SERVICE BULLETIN

SERVICE BULLETIN		No.: MSB-97E55-001	
		Date: 1998-04-15	
Subject: CHANGE IN AIR GAP FOR A/C COMPRESSOR		<Model> (EC,EXP) 3000GT (Z10 (EX,EXP) L400 (PA0V) (EC,EXP) COLT (CJ0A) (EX,EXP) LANCER (CK0A)	<M/Y> 96-10 96-10 96-10 96-10
Group: HEATER, A/C & VENTILATION	Draftno: 97-AL-021		
INFORMATION	OVERSEAS SERVICE DEPT	<i>R. Usami</i> R. USAMI - MANAGER QUALITY INFORMATION ANALYSIS

This Service Bulletin informs you of change in air gap of the clutch for the A/C compressor.

▶ E ◀ AIR GAP ADJUSTMENT

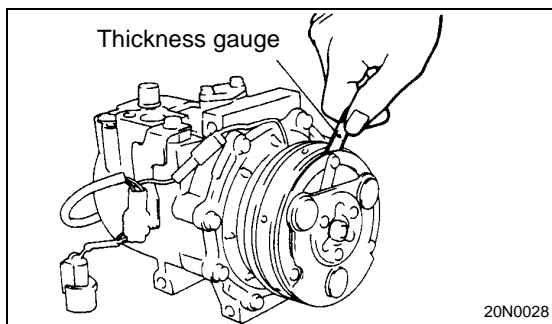
Check whether or not the air gap of the clutch is within the standard value. ~~<Old>~~

Standard value: ~~0.40 - 0.65~~ mm

If there is a deviation of the air gap from the standard value, make the necessary adjustment by adjusting the number of shims.

<New> 0.3 - 0.5
